Access Compliance Report

Public Rights-of-Way

Intersection ID: 10019149	Main Street: ATKINS_RIDGE_DR	Cross Street: N/A	Location: E
ADA ID: E672D1CC14D1	Ramp Type: BlendTrans1	Initial Pass/Fail: Fail	Overall Compliance: No
		Severity Score: 0

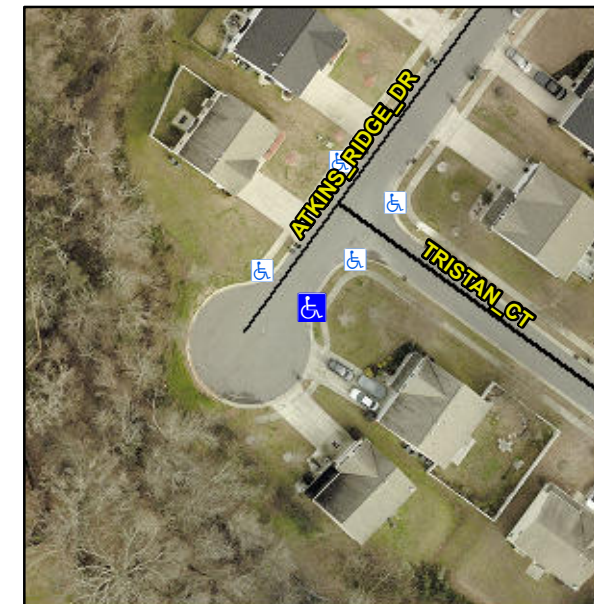
RP < 5%

Compliance	Description	Data	Compliance	Description	Data
N/A	Ramp Length (in)	48.0	Yes	BlendTrans Slope (%)	4.8
Yes	Ramp Width (in)	48.0	Yes	BlendTrans XSlope (%)	0.5
N/A	Flare Type LT	N/A	N/A	Flare Type RT	N/A
N/A	Flare Slope LT (%)	N/A	N/A	Flare Slope RT (%)	N/A
N/A	Flare Traversable LT?	N/A	N/A	Flare Traversable RT?	N/A
N/A	Landing Length (in)	N/A	N/A	DWS Provided?	N/A
N/A	Landing Width (in)	N/A	N/A	DWS Contrast?	N/A
N/A	Landing Slope (%)	N/A	N/A	DWS Length (in)	N/A
N/A	Landing X Slope (%)	N/A	N/A	DWS Full Width?	N/A
N/A	Landing Curb? (Y/N)	N/A	N/A	DWS Offset (in)	N/A
N/A	Shared Landing?	N/A			
N/A	Gutter Ponding?	N/A	N/A	Gutter Slope (%)	N/A
N/A	Gutter Lip Ht (in)	N/A	N/A	Gutter X Slope (%)	N/A
N/A	Painted X Walk1?	No	N/A	Painted X Walk2?	N/A
	X Walk 1 Direction	To NW		X Walk 2 Direction	N/A
	X Walk 1 Width (in)	N/A		X Walk 2 Width (in)	N/A
	X Walk 1 Slope (%)	4.6		X Walk 2 Slope (%)	N/A
	X Walk 1 X Slope (%)	0.6		X Walk 2 X Slope (%)	N/A

N/A	Ramp inside XWalk1?	N/A	N/A	Ramp inside XWalk2?	N/A
	Road Slope (%)	0.6		Clear Space?	N/A
	Road X Slope (%)	4.6	N/A	Clear Space to XWalk (in)	N/A
N/A	Any Obstructions?	N/A	N/A	Storm Grate/Utility Hazard?	N/A
	Obstruction Type			Storm Grate/Utility Type	
		N/A			N/A
			Yes	Surface Condition? (G/P)	Good
			No	Curb Slope (%)	18.9

Remove & Replace Curb Ramp With Two New Directional Ramps or Equivalent.
